**Commonwealth Edison**  
One First National Plaza, Chicago, Illinois  
Address Reply to: Post Office Box 767  
Chicago, Illinois 60690

Subject: Dresden Station Units 2 and 3  
Additional Information on Safe  
Shutdown Paths (Appendix R)  
NRC Docket Nos. 50-237 and 50-249

This transmittal provides additional information regarding our Appendix R exemption requests currently under review. The information provided in the enclosure documents our response to questions previously discussed during teleconferences with your staff in September, 1985.

FIGURE 1. REACTOR WATER CLEANUP SYSTEM

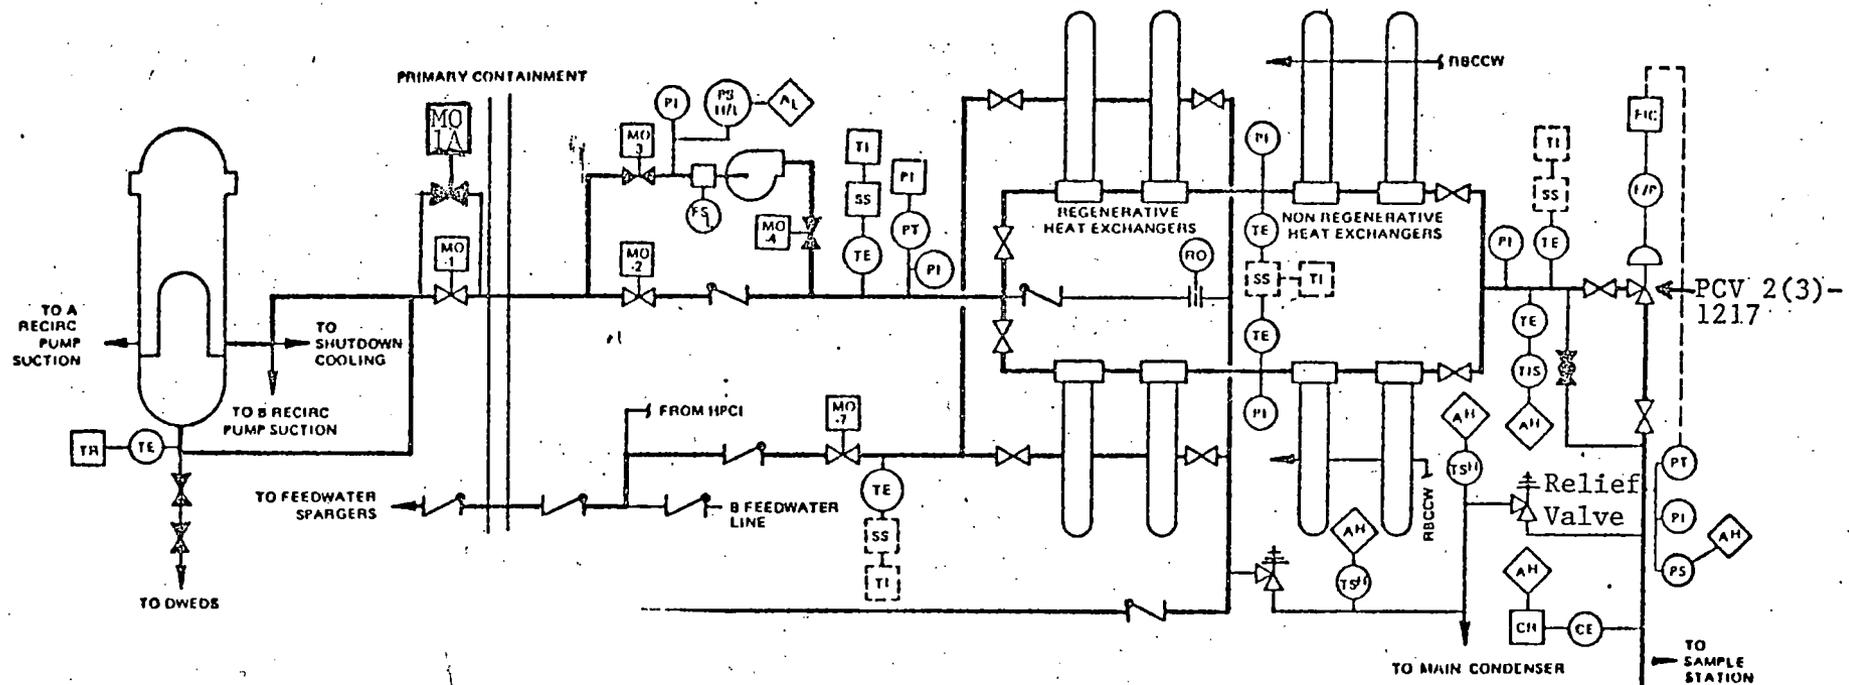
3b. Will the closure of the above single valve ensure RWCU isolation? (This question arises because you have listed 5 valves for this system).

Response Yes, because closure of this valve will isolate rest of system and any spurious operations downstream of this valve would have no effect. The MO2(3)-1201-3 and MO2(3)-1201-4 valves are in a line which bypasses the MO2(3)-1201-2 valve and are normally closed (see attached drawing). No high-low pressure interface exists.
